UNIVERSITY OF VIRGINIA
NUCLEAR REACTOR FACILITY

Subject: UNIVERSITY OF VIRGINIA – (Second) REQUEST FOR ADDITIONAL INFORMATION
RE: DECOMMISSIONING AMENDMENT REQUEST (TAC NO. MA8186).

**UVA RESPONSE TO NRC REQUEST FOR ADDITIONAL INFORMATION
UNIVERSITY OF VIRGINIA RESEARCH REACTOR
DOCKET NO. 50-62**

Figure 1: Pond Sediment Sampling Locations And Groundwater Monitoring Well Locations

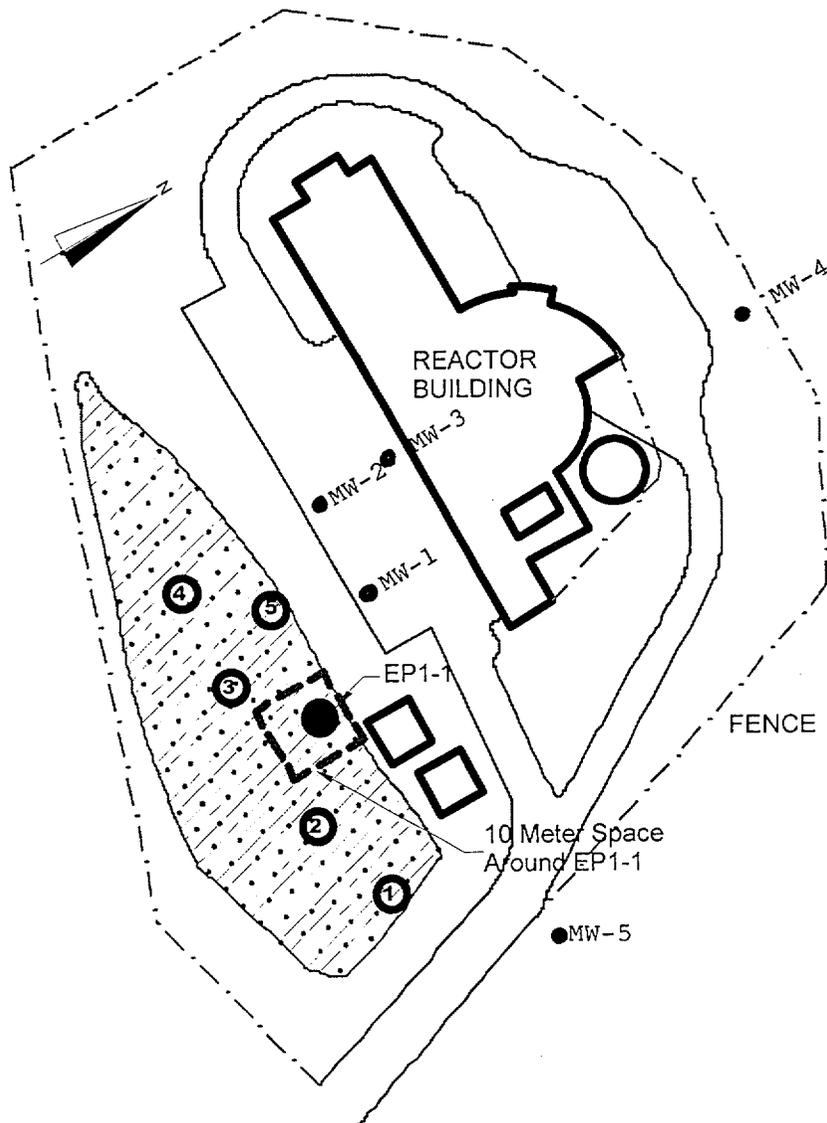
10. Please describe the plan for characterizing the pool leakage pathways. Will this include an investigation of the hydrology present on the site? If not please justify. Will the characterization include sampling existing waterways, existing wells, and test wells? If not, please justify.

- 11. Beginning on page A-3 of Appendix A of the DP (Ref. 3)" ...areas that will require remediation or further investigation and evaluation..." are listed. One sample, Location No. 14, was a composite sample of pond sediment taken at the outfall area of the liquid waste holding tank bunker. As indicated on page A-6 of the DP and in Table 7.4 of the UVAR Characterization Survey Report (CSR) (Ref. 5) levels above the DCGLs for Co-60 and Cs-137 were found. Please discuss the plan for further characterization, evaluation, and remediation of the pond sediment. Please provide the estimate of the impact this activity will have on the schedule, personnel dose, waste volume, and decommissioning cost.**

Mr. Sitler re-visited the UVAR site in early April, 2001, to advise on how additional hydrological site characterization could be conducted. Suitable locations (please see Figure 1 in attachment) were found for two additional groundwater test sampling wells, one (MW4) directly north of the Reactor building (hydrologically upstream in unimpacted groundwater), and the other (MW5) near the pond retaining wall (hydrologically downstream, at a potentially impacted location). UVA is hereby committing to NRC that it will have these groundwater sampling wells drilled. The additional water table data to be obtained is expected to confirm the present understanding of the site hydrology. In addition, water samples from new and existing site wells, nearby wells on the other side of the hillside on which the UVAR site is located, and nearby surface waters, will be taken and evaluated for a potential UVAR poolwater leak impact.

The statement on page A-6 of the DP indicating that Cs-137 was in excess of the DCGLs was incorrect. The sample result for Cs-137 was 3.7 pCi/g and the DCGL for Cs-137 is 11 pCi/g. However the Co-60 result, 9.5 pCi/g, was in excess of the DCGL, 3.8 pCi/g, as indicated. The attached survey map (please refer to attached Figure 1) shows as circled

numbers the sediment sample locations 1 to 5 plus sample locations EP1-1. Only sample location EP1-1 had activity in excess of the proposed DCGLs as indicated on the attached pond sample result table (please see Table 1 in attachment). The EP1-1 sample was taken in the immediate vicinity of the drainpipe from the reactor building. The 10-meter space on the map shown around sample location EP1-1 indicates the maximum anticipated extent of contamination.

Figure 2: Office of Environmental Health and Safety
Organizational Chart

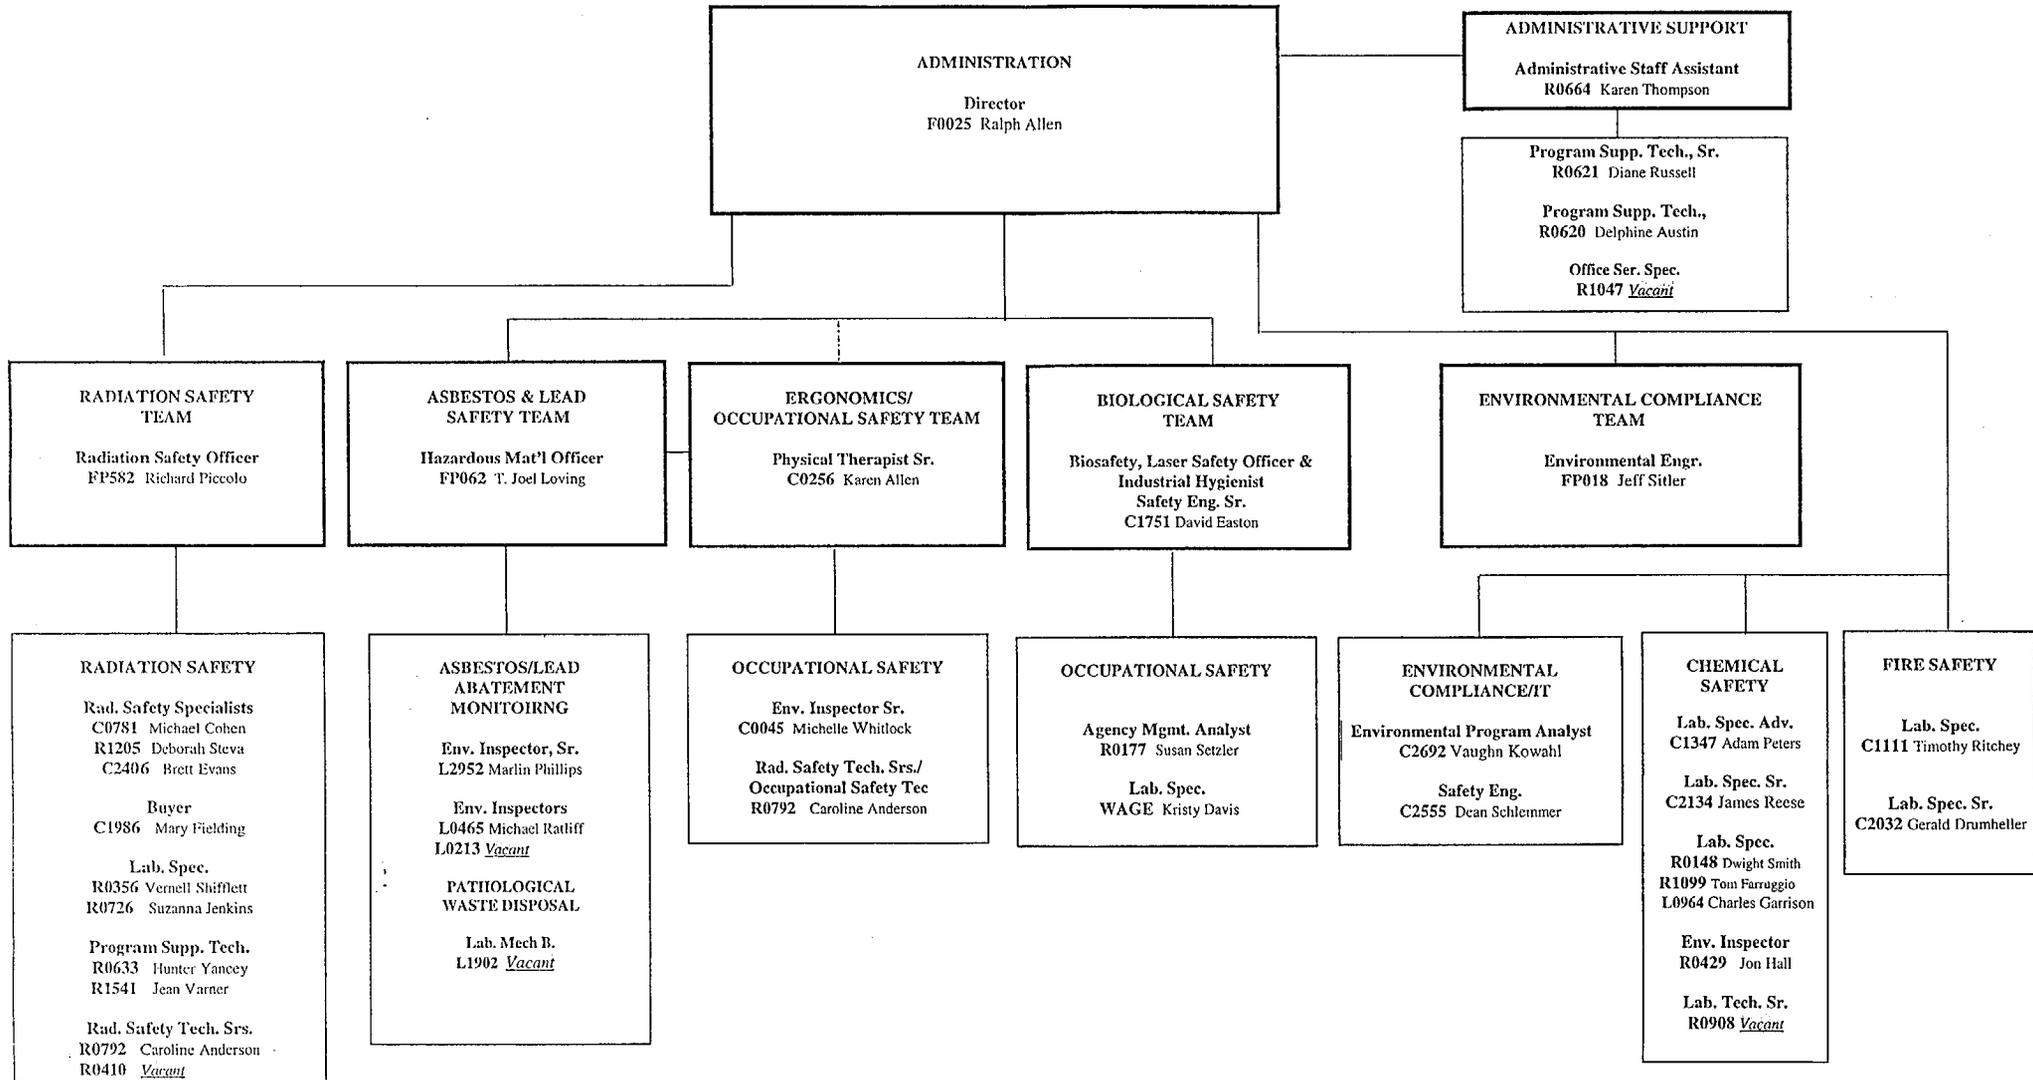
4. **The position "UVA Industrial Hygiene (IH)" is referred to in the Respiratory Protection part of section of 3.1.2 of the DP (Page 3-8, Ref. 3). Please provide the position with supervisory control over the IH position. Please list the responsibilities of the IH position.**

6. **What are the distinctions and relations between the Radiation Work Permit (RWP) and the Hazardous Work Permit (HWP)? Both are referenced in section 3.2.2 of the DP (Page 3-18, Ref. 3). With whom lie the responsibilities associated with HWPs?**

The UVA industrial hygienist (certified by the American Board of Industrial Hygiene), serving as Biosafety, Laser Safety Officer and Industrial Hygienist Safety Engineer Sr., will be consulted to advise the decommissioning contractor on issues about air quality and the use of respiratory protection. The Director of Environmental Health and Safety, who also serves as Chairman of the Decommissioning Committee, has supervisory control over this position. (Please refer to Figure 2, in attachment, which depicts the organizational chart of the Office of Environmental Health and Safety.)

An HWP will be used when controls are imposed to protect against non-radiological hazards. Depending on the hazard, the appropriate OEHS specialist will assist with the development of the HWP. The UVA Occupational Safety Environmental Inspector Sr. will be responsible for approval of HWPs. The Director of Environmental Health and Safety, who also serves as Chairman of the Decommissioning Committee, has supervisory control over the Environmental Inspector Sr. position. (Please refer to Figure 2, in attachment, which depicts the organizational chart of the Office of Environmental Health and Safety.)
